P&Z STAFF REPORT

Board of Appeals Hearing; July 10, 2018

Case: **V18-0008 and V18-0009 – 5775 Peachtree Dunwoody Road**

Case: **V18-0011 – 1001 Johnson Ferry Road**

SITE PLAN (FULL SITE PLAN AS ATTACHMENT)

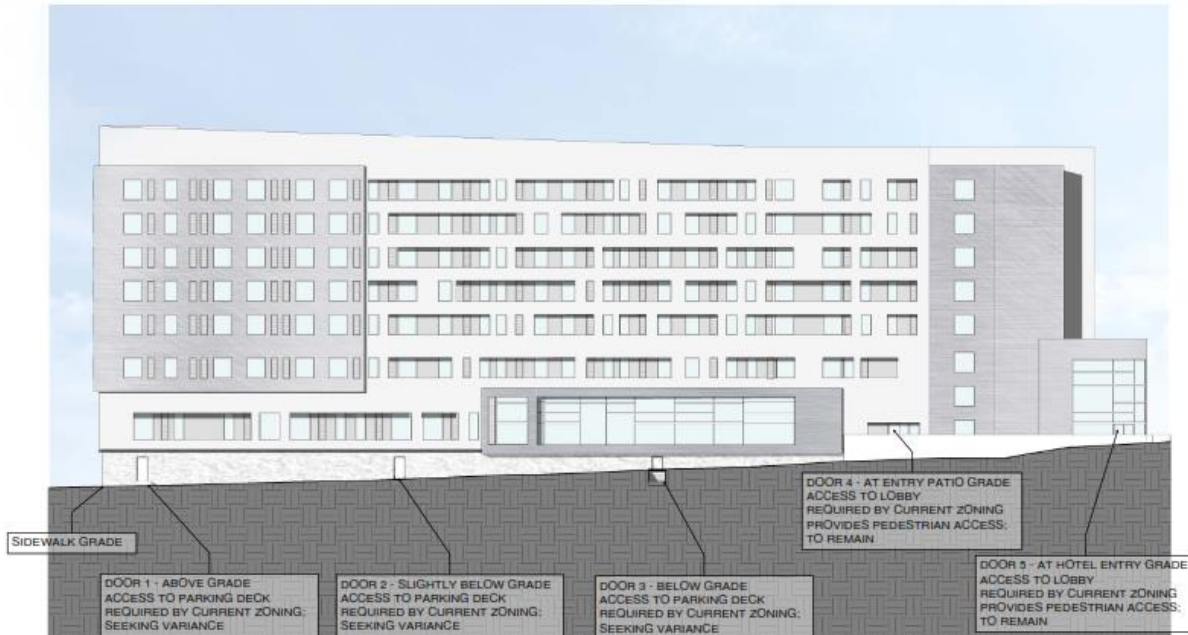
The first Variance (V18-0008) is requested to eliminate some pedestrian access points along Peachtree Dunwoody Road which are required every 75 feet, per Sec 5.6.4. Due to the slope, the hotel and deck

will be located below the road grade or downhill from Peachtree Dunwoody Road. In light of the existing slope and safety concerns related to having additional doors entering into a parking deck, the applicant is requesting relief from the pedestrian access requirement. At this time, the main entrance to the lobby is located at the corner of the future private road and an additional access from Peachtree Dunwoody is provided just north of the main entrance.

The applicant is providing two pedestrian access points at the South end of the property as entrances to the lobby, which will be a public space. The applicant is requesting to waive the requirement for the remaining three required access points along Peachtree Dunwoody Road. Due to the design of the structure and the 10 foot downward slope along Peachtree Dunwoody Road, these three pedestrian access points will not provide access to the hotel itself, but rather the underground parking garage.

These both seem like reasonable requests. The building is not long enough to meet the frontage requirements on all three streets; making it so would probably create some long-term operational inefficiencies in guest floor layouts.

Maintaining the pedestrian access requirement in this case doesn't seem to provide any benefit, functional or aesthetic, to the community. To be most effective, this requirement needs to be coupled with the transparency requirement, which in this case, is being implemented on the building's first active level. Were it not for the grade change along PDR, implementing this requirement could work.

It does seem, however, that providing some guest access from the sidewalks around the north end of the building would provide some pedestrian benefit.

1. To provide an additional pedestrian access near the Peachtree Dunwoody Road and Lake Hearn Drive intersection. This access may be controlled and limited to registered hotel guests.

DETAILED SITE PLAN

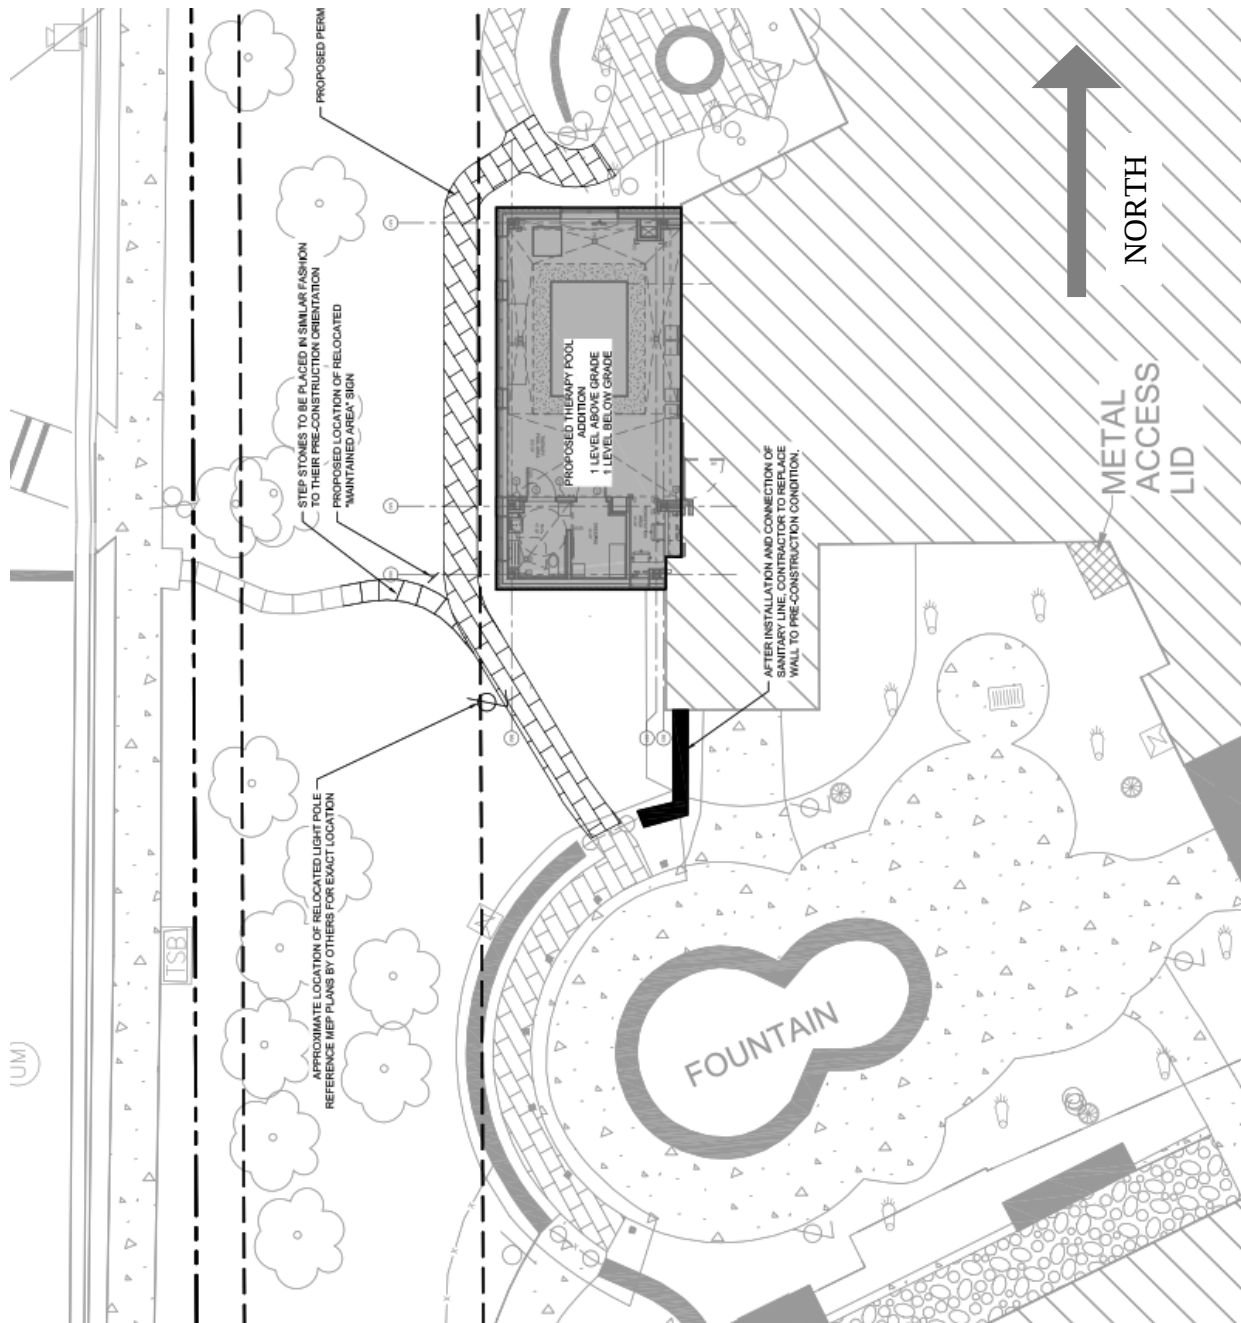
It would help to have more information. Since this is a tiny addition to a large building, it would help to be able to see it in the context of the entire elevation. It is essentially an alteration of the existing facade.

It would also help to have the elevations for a transparency calculation. I get 44-45% in a rough take-off from the material we do have.

The elevations might also help in understanding what view blockages from patient rooms might occur. It appears that there are only two rooms that would potentially be affected.

It would also be helpful to know the height(s) of the rooftop equipment and to have some sightline studies of the proposed design, as the building appears to be several feet above the street.

1. A light-weight screen similar to a decorative fence is provided for screening around the mechanical equipment.
2. Transparency of 29% or greater is provided on the street-facing façade.
